**RESOLUTION SETTING HEARING ON REQUEST FROM  
HDR LAND DEVELOPMENT, LLC TO REZONE PROPERTY  
IN THE VICINITY OF 4896 EASTON BOULEVARD**

HDR Land Development, LLC, Vicinity of 4896 Easton Boulevard

ZON2017-00036

## **STAFF REPORT TO THE PLANNING COMMISSION**

**SIGN REQUIREMENTS**

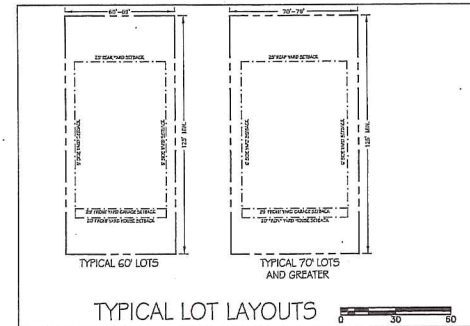
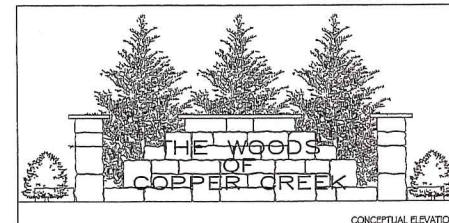
**12. Additional Information:** The PUD Conceptual Plan proposes an entry sign along NE 23<sup>rd</sup> Avenue (Easton Boulevard) at each of the proposed north/south streets. The conceptual diagram indicates that each sign would be constructed with stone and masonry materials.
